寄件者: Andrea Wing Yin YAN/PLAND
寄件日期: 2026年08月10日星期一 10:36
收件者: tpbpd/PLAND
副本: Yen PY LEUNG/PLAND; Ivan Sze Yuet FUNG/PLAND
主旨: Fw: S. 16 Planning Application No. A/YL-KTN/1251 - Departmental Comments
附件: KTN1251_回應運輸署意見(6Aug2026).pdf; KTN1251_LD-L1198B-SW01.pdf

S. 16 Planning Application No. A/YL-KTN/1251 - Departmental Comments

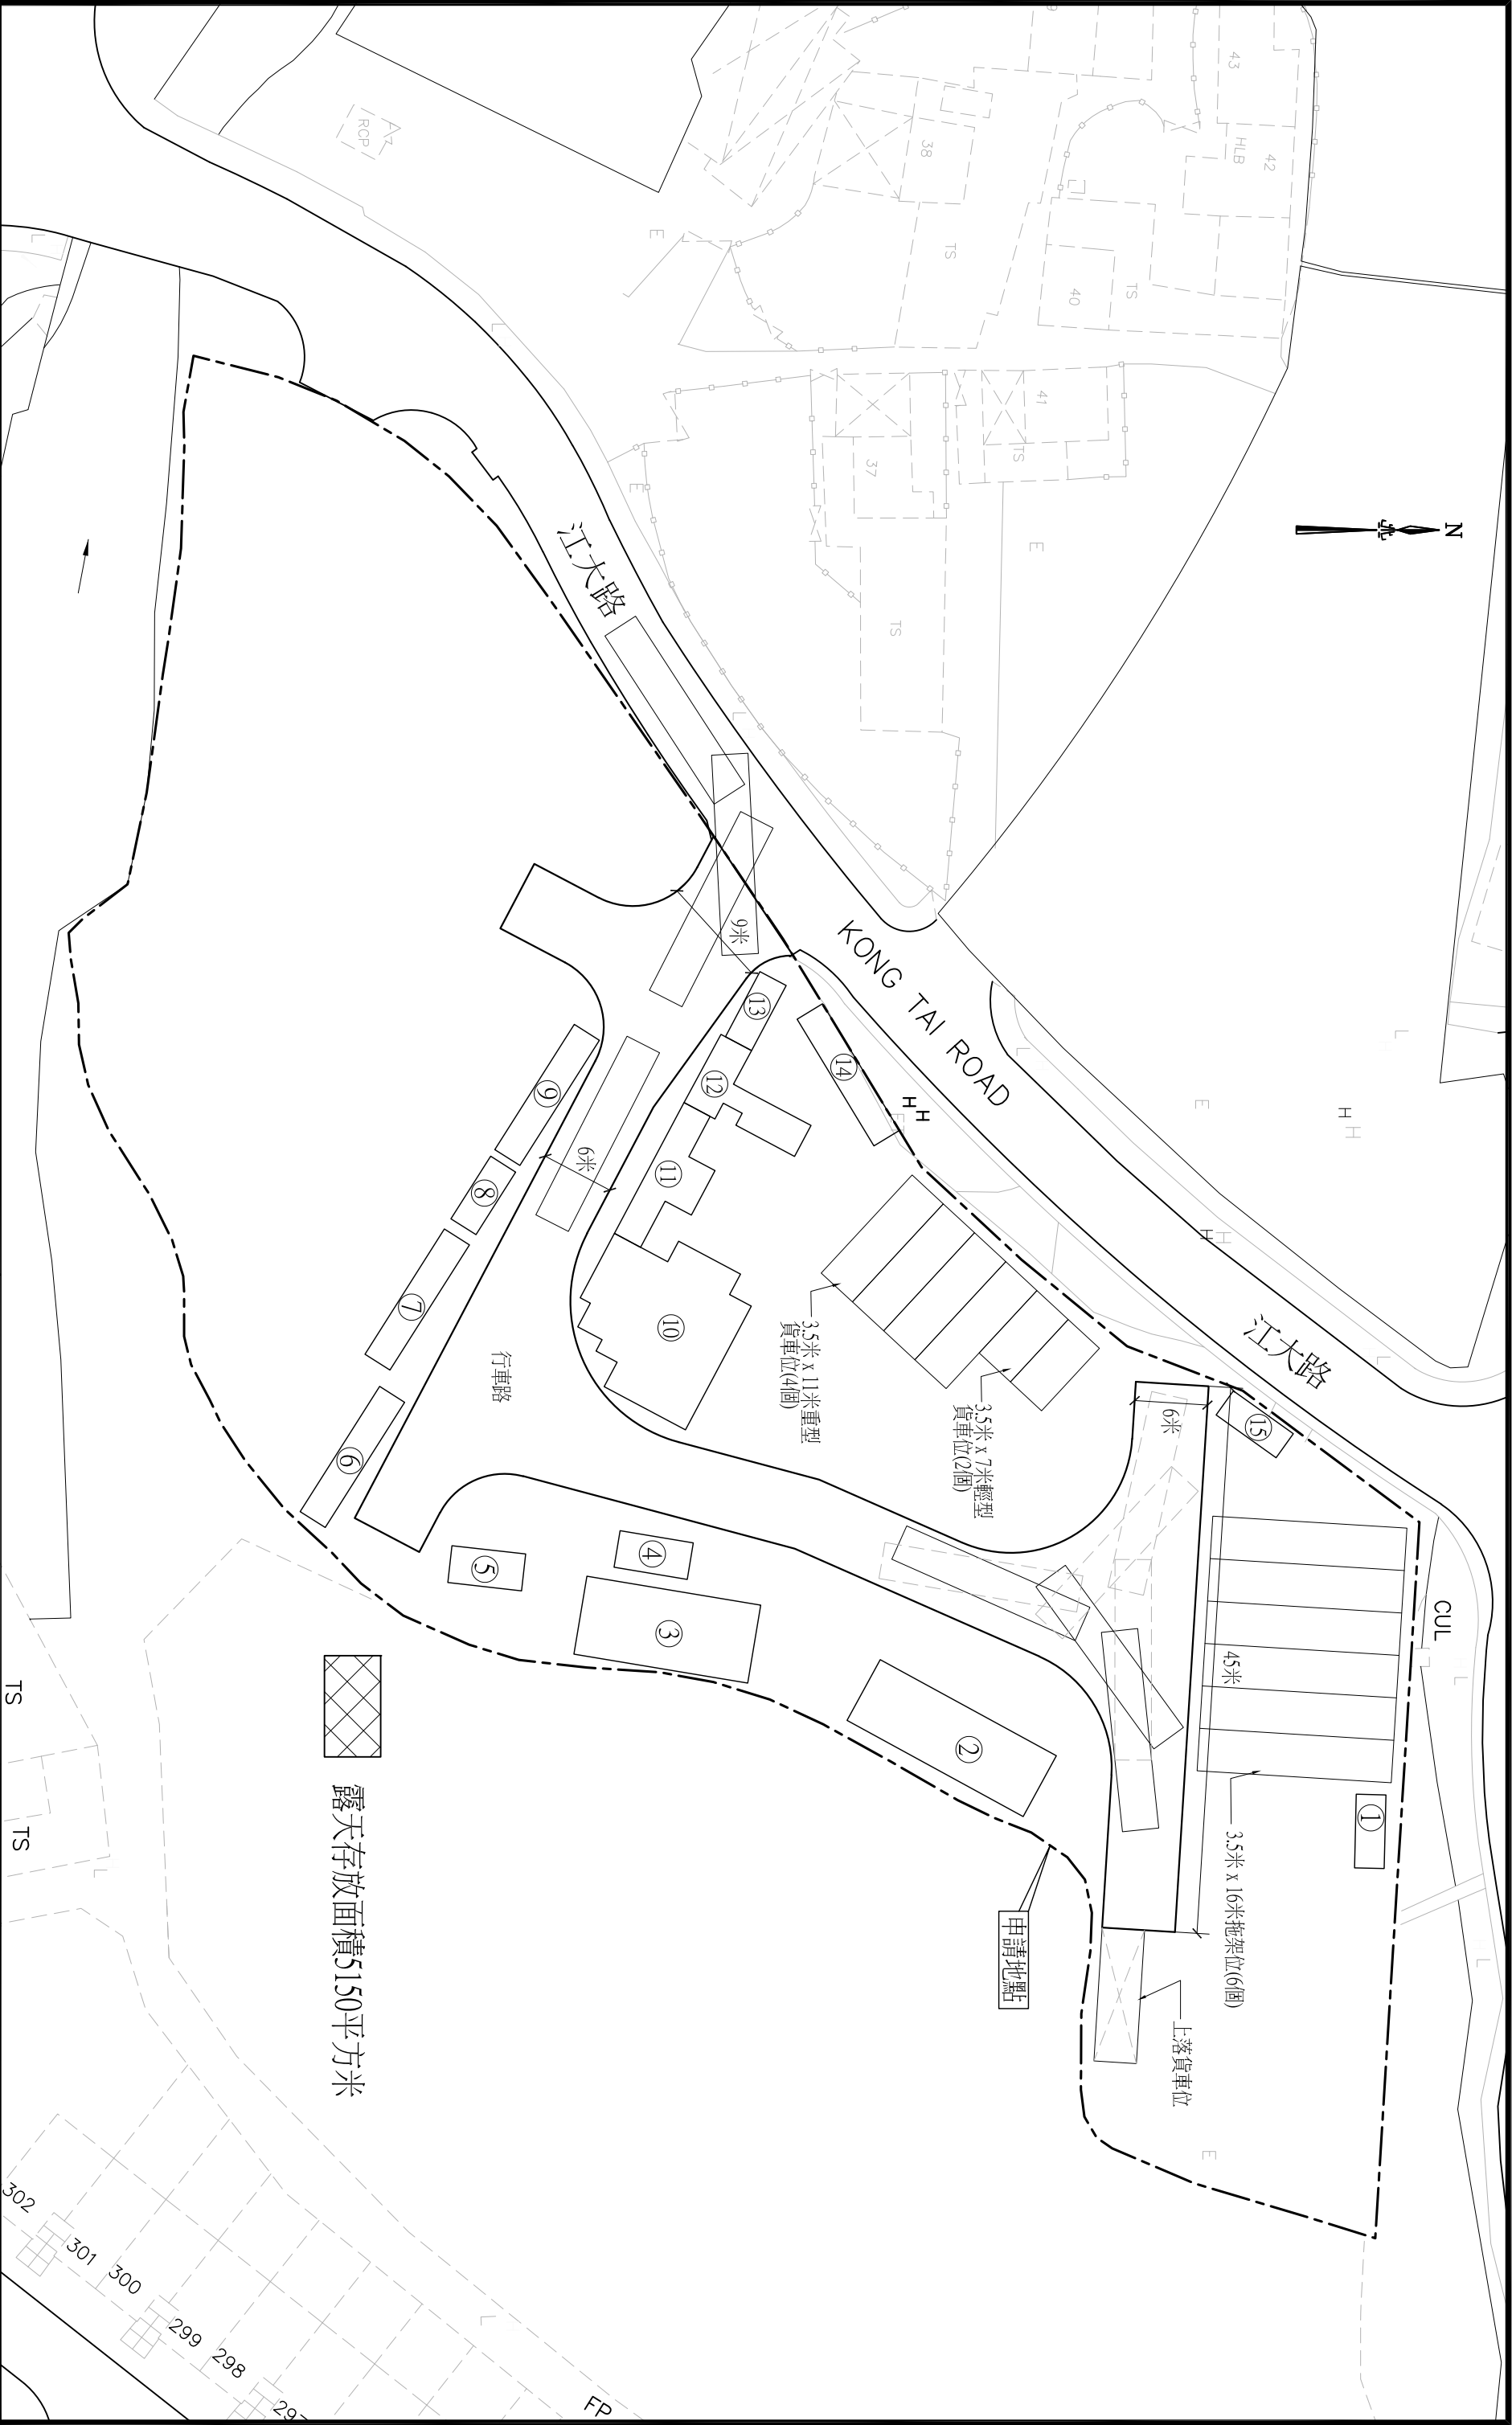
(a) The applicant should provide the trip generation and attraction due to the development and assess the traffic impact to Kong Tai Road and the local access;	申請地點的日常運作時間為星期一至六，上午 9:00 至 18:00，星期日及公眾假期休息，進出場地車次量估計(附行車車量估算表)以日車輛只有三至四次，而現場作補充物料或在場調配的吊車次數估計大概兩星期才有一次補貨，車輛在申請場內調度，因此不會影響接連的大江路。
(b) The site entrance is 6m wide and is unlikely to facilitate the operation of long vehicles. The applicant should demonstrate the smooth manoeuvring of vehicles to / from Kong Tai Road, along the local access and within the site;	申請場地出入口有約十一米及閘門 6 米闊，按照操作中常使用最大的總重 24 噸三軸吊雞車 (11m x 2.6m x 4.2m (長度 x 闊度 x 高度))，申請場地有明確入口及路面具備足夠寬度行、申請場地內亦有泊車空間及緩衝區(見附圖)，車輛進出當地路、沿週邊道路及在申請場地內是通行順暢。
(c) The applicant should note the local access between Kong Tai Road and the site is not managed by this Department.	申請人是會留意申請場地現場的周邊道路是已開通，是沒有業權上或可否使用上的爭議，申請亦會按日常操作，妥善管理此一段路及場內通路保持整潔，確保不阻礙或影響其他使用此段路的路人或村民。
